CHANGE ORDER

Project Title Overhaul Base Apron Rehabilitation - Phase II

Change Order No: 1 Date of Issuance: 10-Oct-22

Change Order No. 1 issued to incorporate the attached P-156 Substitution Request, P-219 Substitution Request, RFP No. 1 and RFP No. 2.

SITE PLAN - 2 OF 5

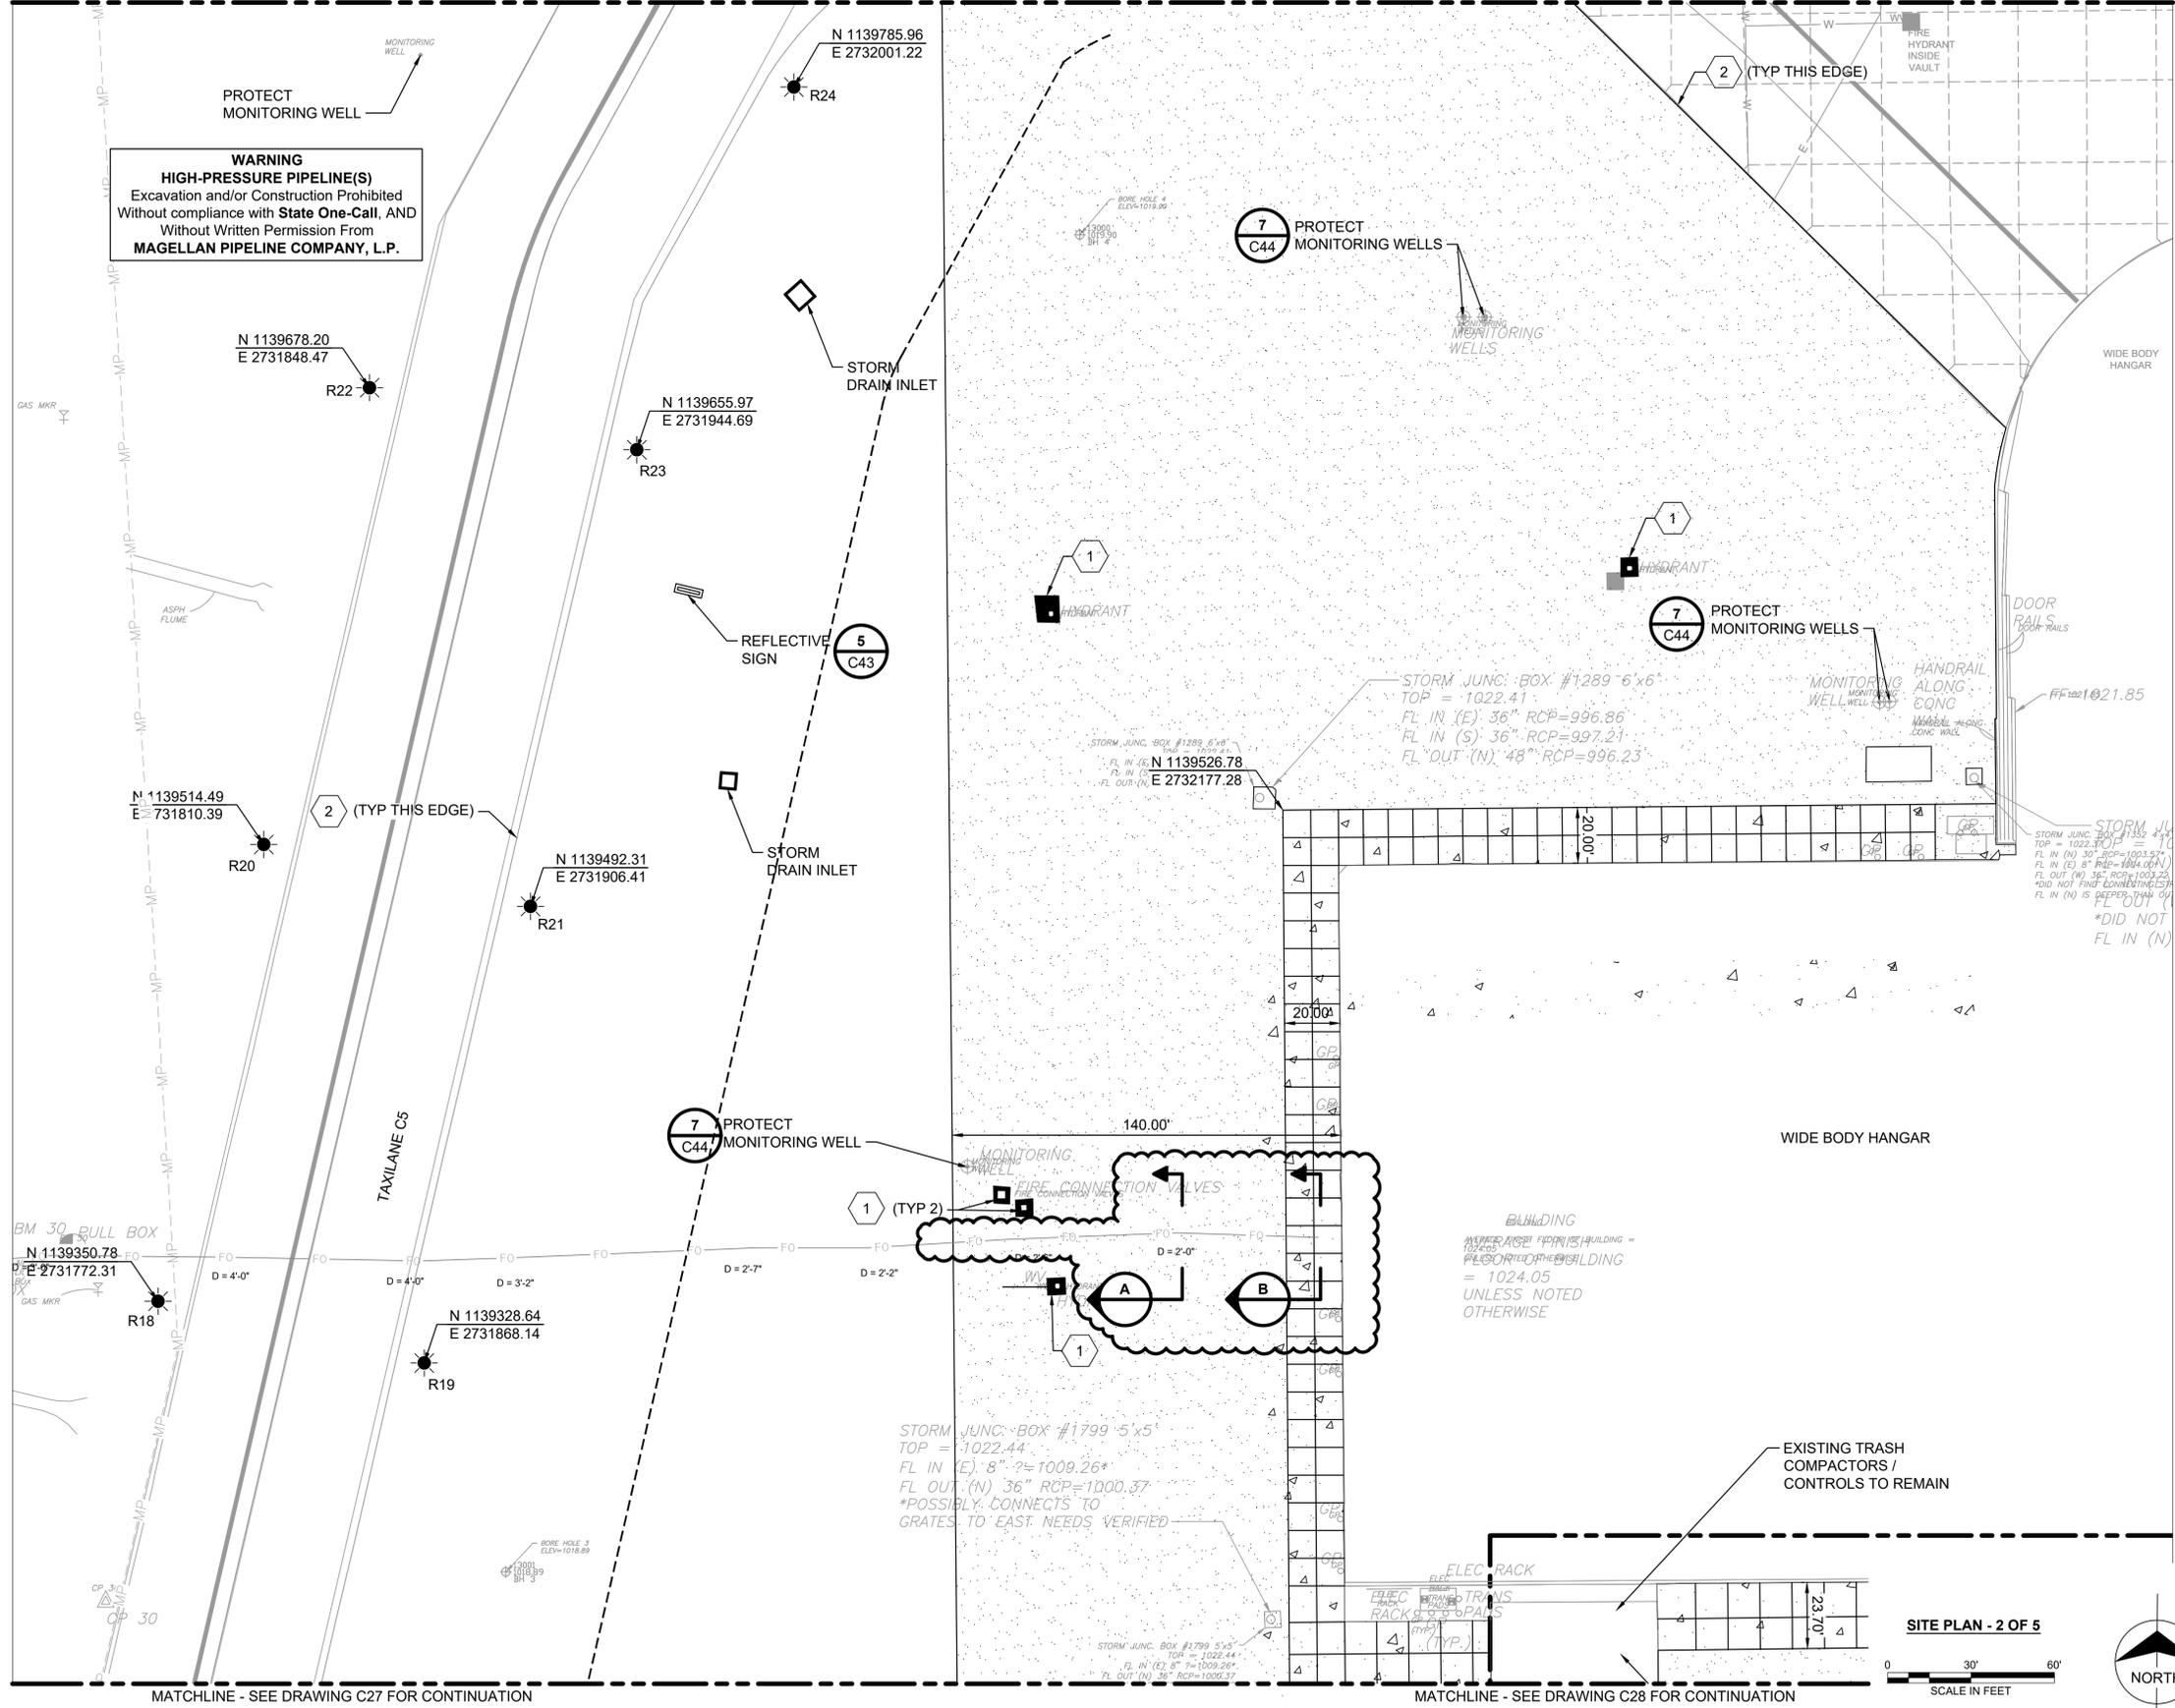
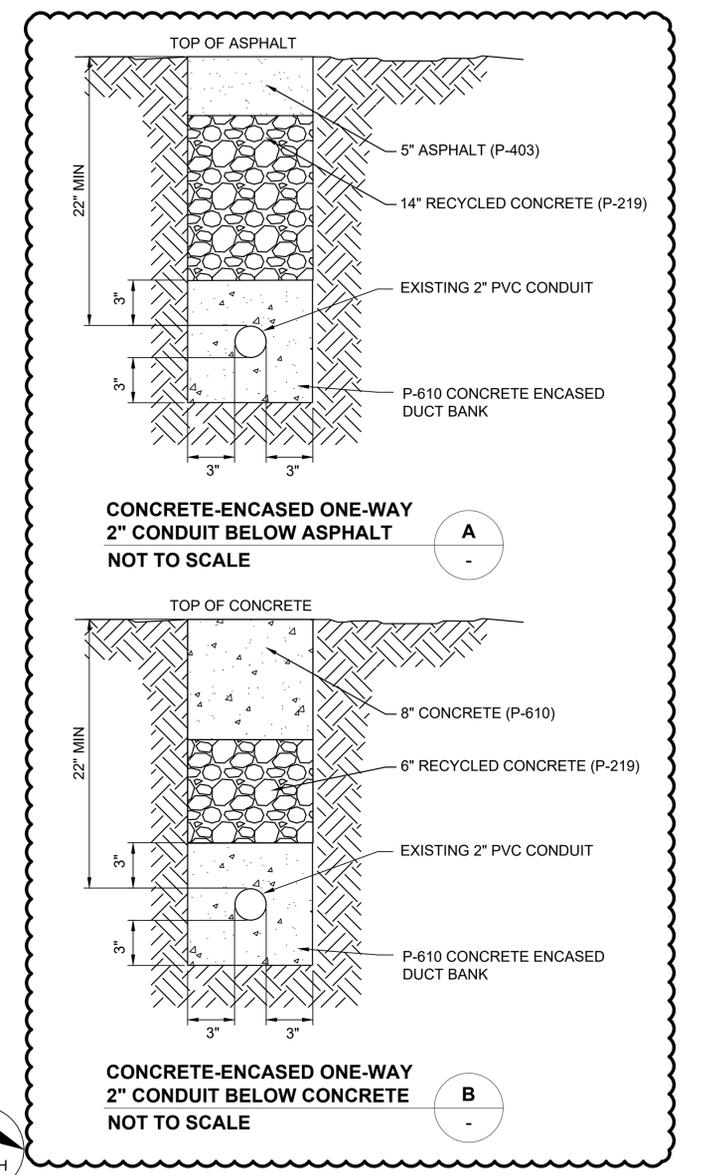
To protect this existing conduit containing the fiber optic lines, the existing conduit will be encased in concrete (P-610) as shown on revised Drawing C26 Site Plan – 2 of 5 attached to this Request for Proposal. The existing conduit shall be encased with a minimum of 3" of P-610 concrete surrounding the conduit.

Please provide a per linear foot (LF) price to construct the concrete encasement around the existing fiber optic conduit as shown on revised Drawing C26 Site Plan – 2 of 5 including all labor, materials, equipment and incidentals necessary to construct the concrete encasement. Contractor shall protect the conduit for the full length across the project site including protecting the conduit when constructing the P-219 recycled concrete aggregate base course above the concrete encased duct.

OVERALL SITE PLAN	
design MCG	CAD File: 2-62200517C18.DWG
drawn SML	dwg date 04-01-21
Aviation Project No. 62210547	dwg. no. C24 25 of 45

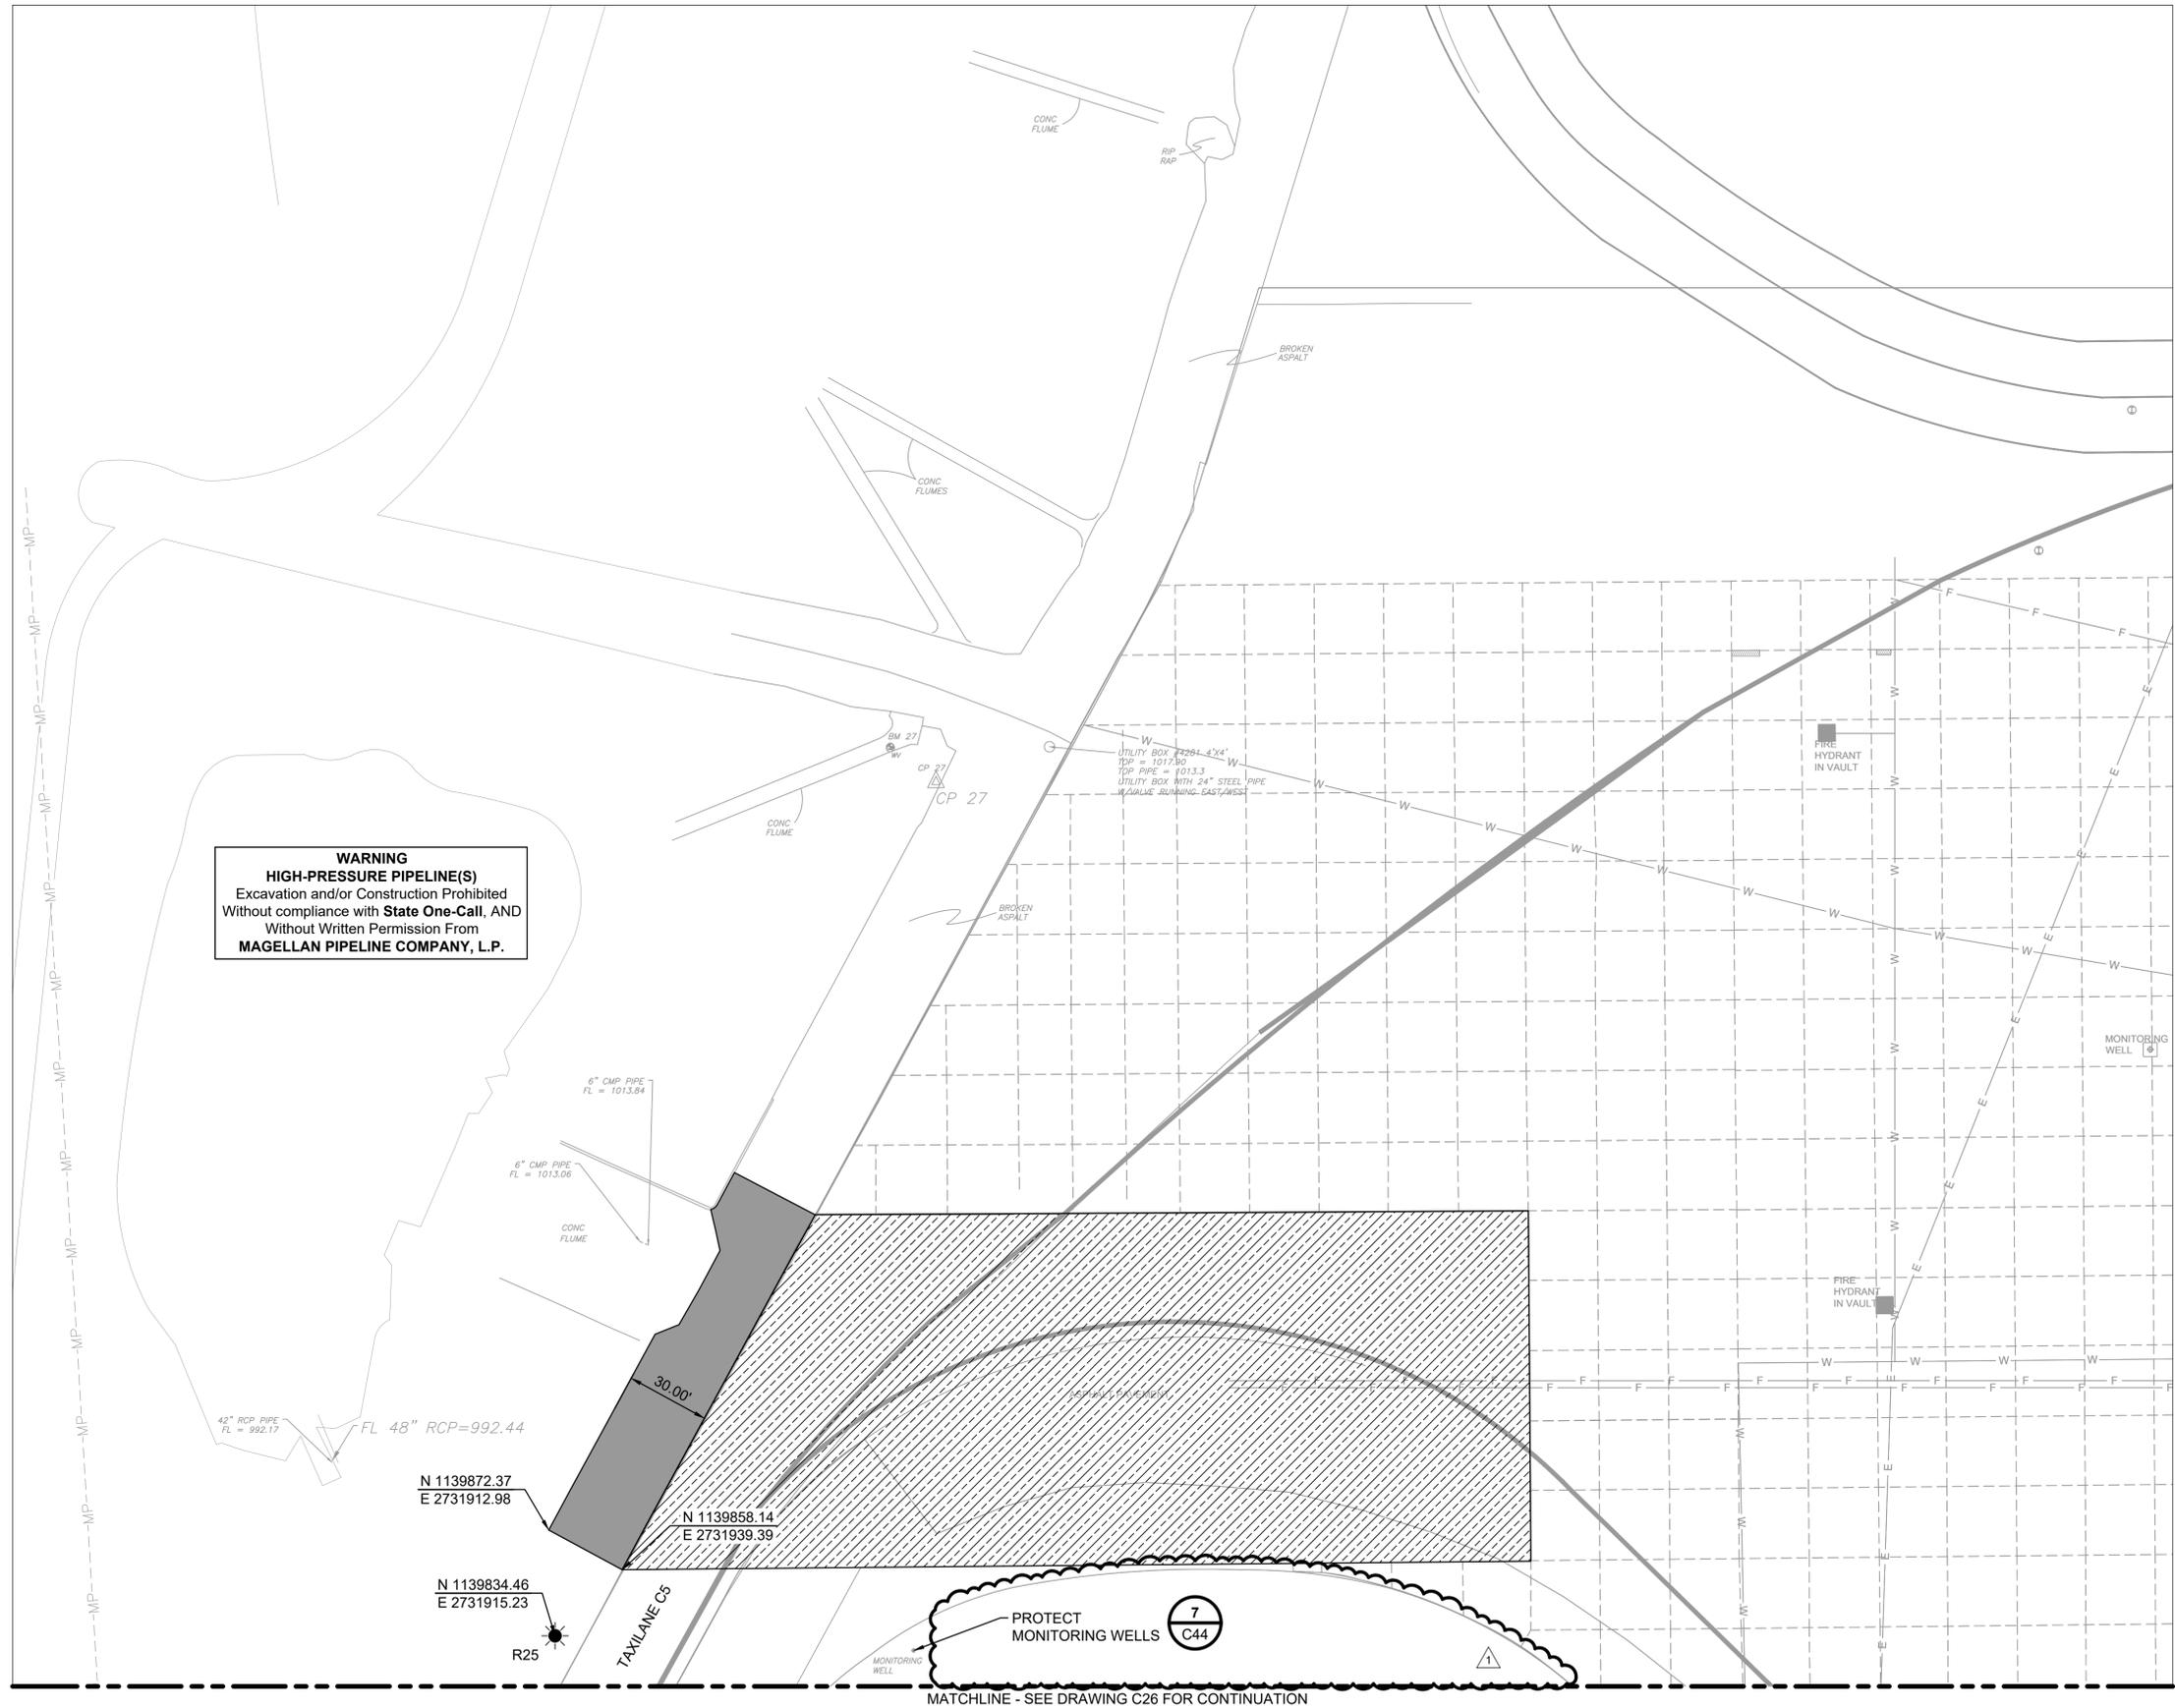
Please provide a new lump sum (LS) price to address the transition period between the regrading of this area until the drainage components (pipes and drainage structures) are installed to drain this area including all labor, materials, equipment and incidentals necessary to prevent the runoff of water/silt from this area across Taxilane C5.
